UNITED STATES PATENT AND TRADEMARK OFFICE

APPLICATION NO.	FILING DATE	FIRST NAMED INVENTOR	ATTORNEY DOCKET NO.	CONFIRMATION NO.
10/072,707	02/05/2002	Alain Houle	CISCP730	1909
54406	7590	09/21/2005	EXAMINER	
AKA CHAN LLP / CISCO 900 LAFAYETTE STREET SUITE 710 SANTA CLARA, CA 95050			KIM, DAVID S	
			ART UNIT	PAPER NUMBER
			2633

DETAILED ACTION

Fig. 1

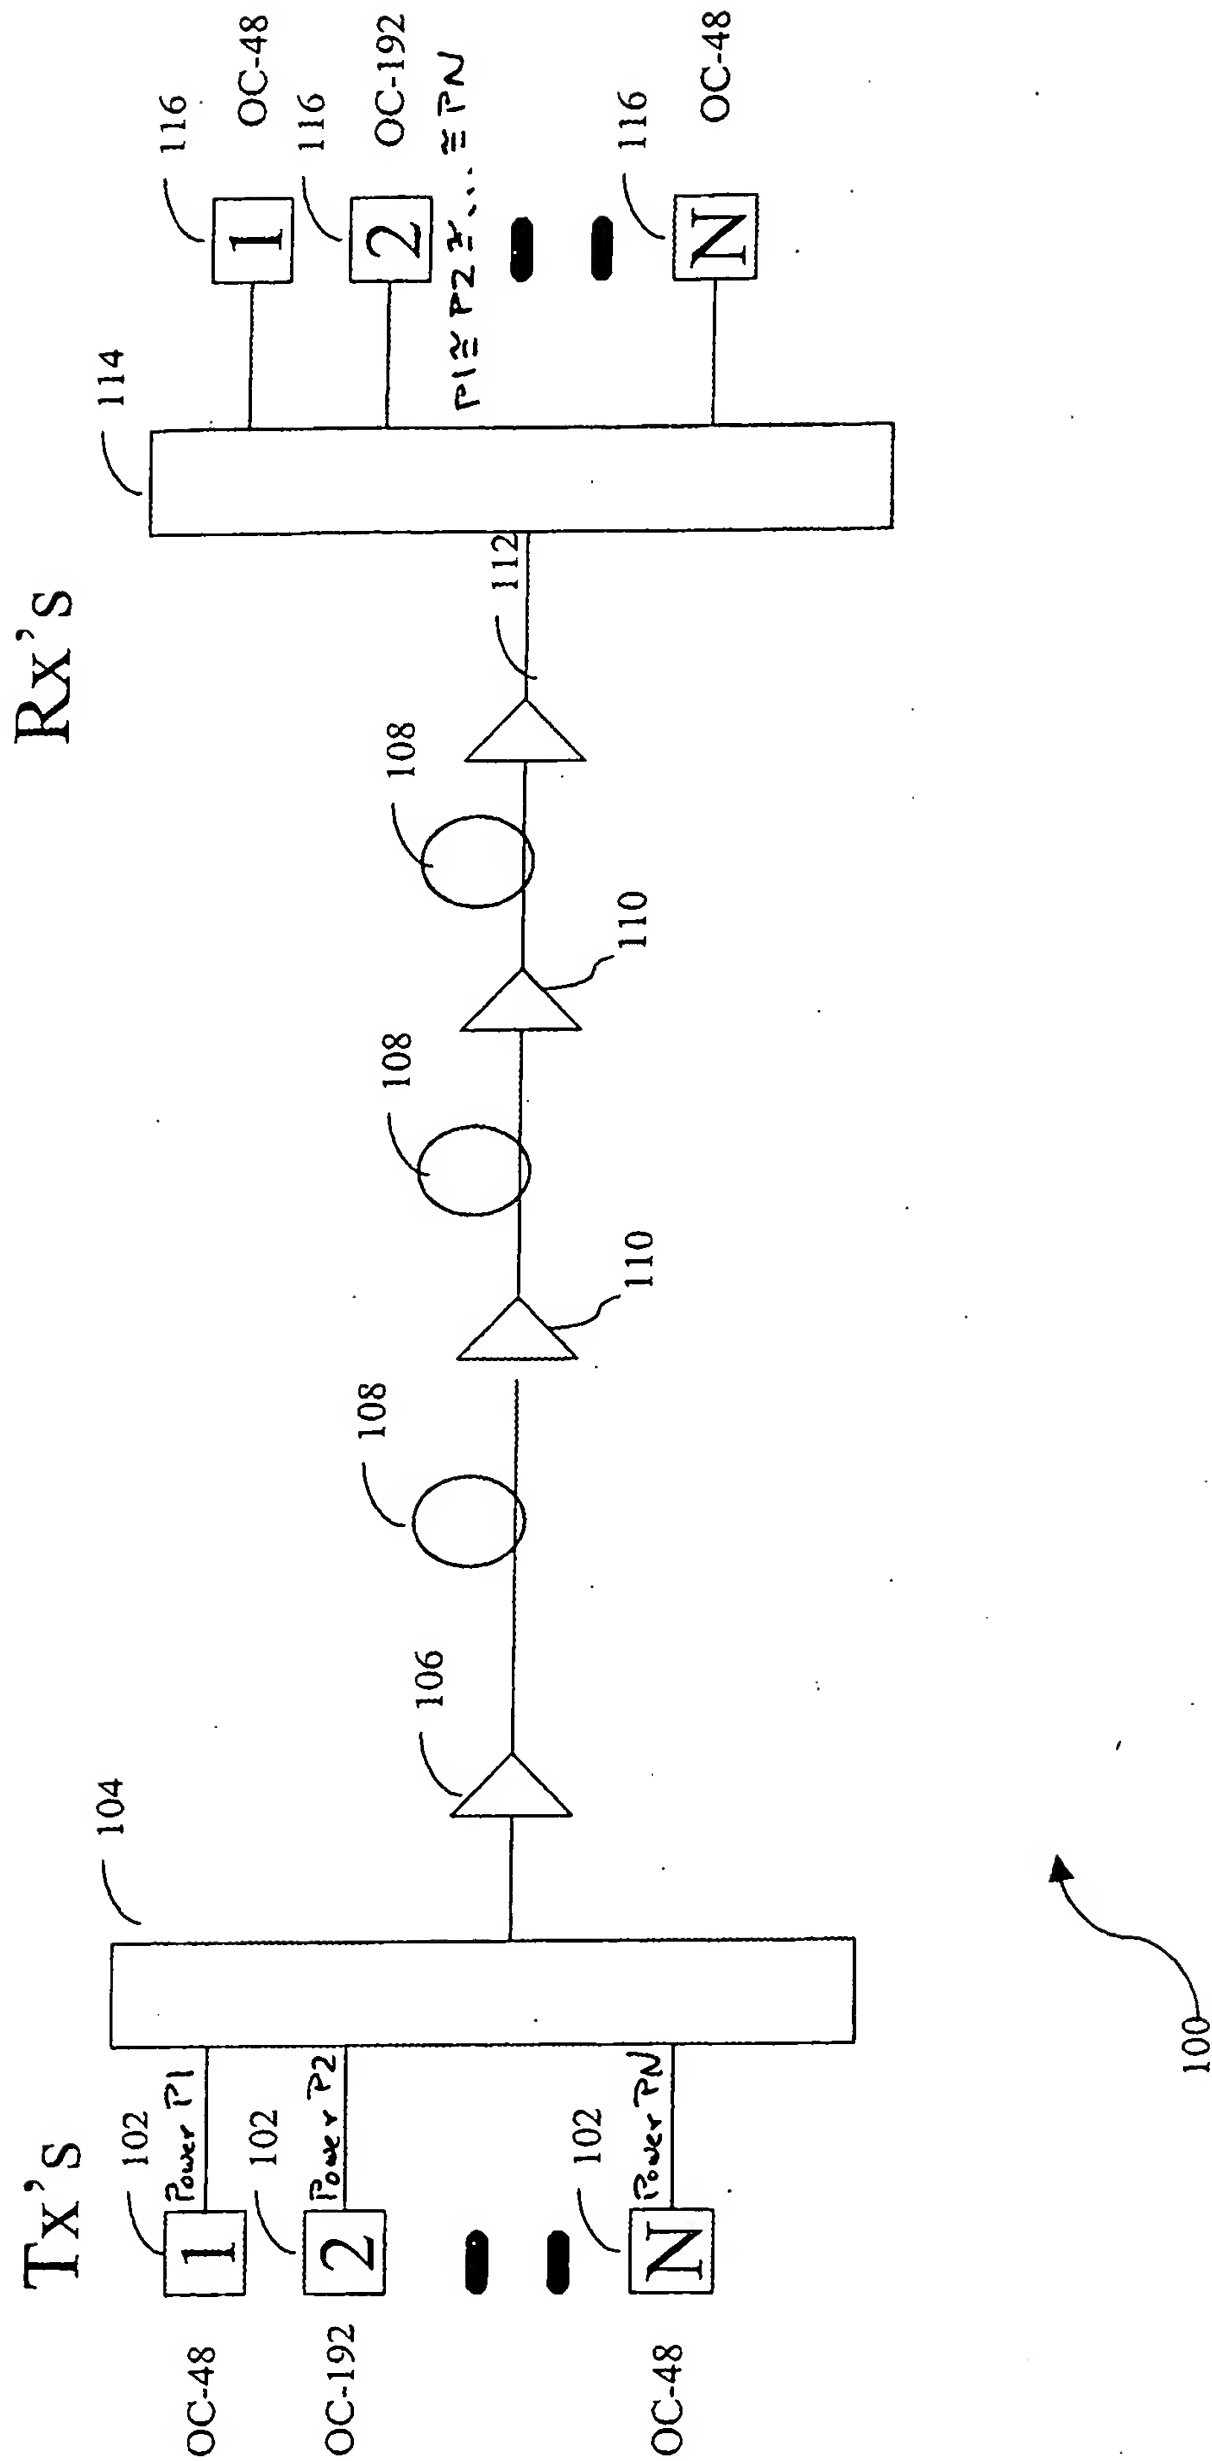
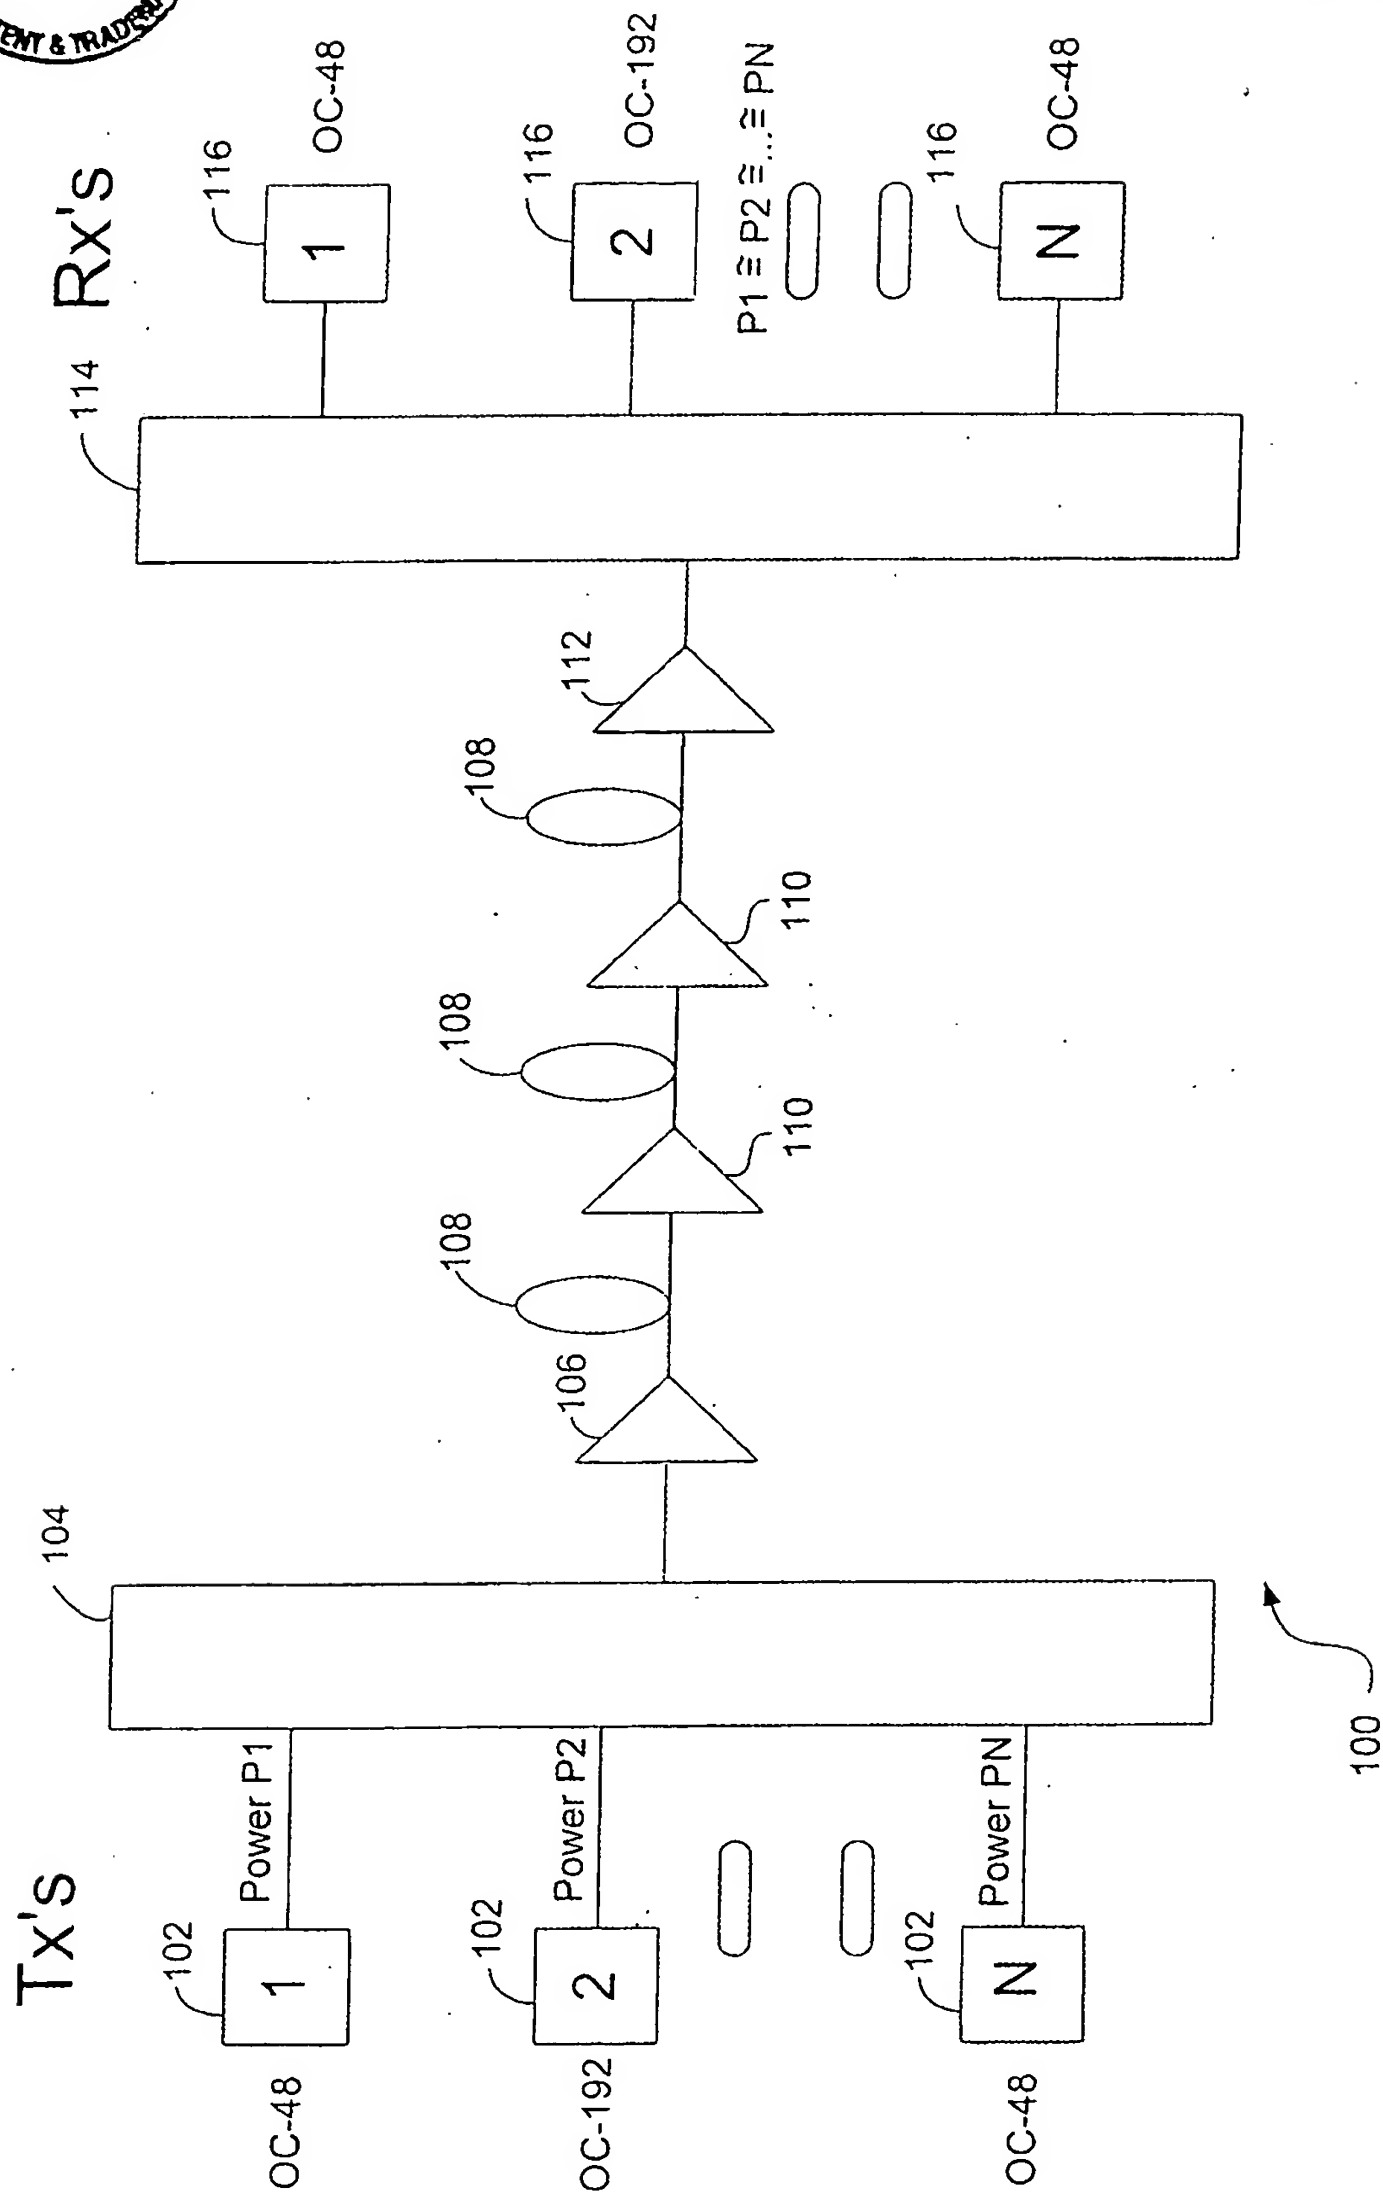
1. Applicant's response to the objections to the drawings in the previous Office Action (mailed 17 December 2004) is noted and appreciated. The replacement drawings were received on 24 March 2005. Figs. 2-3 and 4B are approved. Figs. 1 and 4A are disapproved. The drawings are still objected to under 37 CFR 1.83(a). The drawings must show every feature of the invention specified in the claims.

Therefore, the following features must be shown or the feature(s) canceled from the claim(s):

(claim 7) wherein said first modulated optical signal and said second modulated optical signal have substantially similar power levels *when multiplexed together* (emphasis Examiner's) and

(claim 21) wherein *amplified* power levels of said first modulated optical signal and said second modulated optical signals are substantially similar (emphasis Examiner's).

Fig. 1 shows substantially similar power levels only *when received*. Fig. 1 does not show substantially similar power levels when the optical signals are *multiplexed together* or when the optical signals are *amplified*.

Disapproved by DSL
10 SEPTEMBER 2005

Disapproved by DSK
10 SEPTEMBER 2005

No new matter should be entered.

2. Corrected drawing sheets in compliance with 37 CFR 1.121(d) are required in reply to the Office action to avoid abandonment of the application. Any amended replacement drawing sheet should include all of the figures appearing on the immediate prior version of the sheet, even if only one figure is being amended. The figure or figure number of an amended drawing should not be labeled as "amended." If a drawing figure is to be canceled, the appropriate figure must be removed from the replacement sheet, and where necessary, the remaining figures must be renumbered and appropriate changes made to the brief description of the several views of the drawings for consistency. Additional replacement sheets may be necessary to show the renumbering of the remaining figures. The replacement sheet(s) should be labeled "Replacement Sheet" in the page header (as per 37 CFR 1.84(c)) so as not to obstruct any portion of the drawing figures. If the changes are not accepted by the examiner, the applicant will be notified and
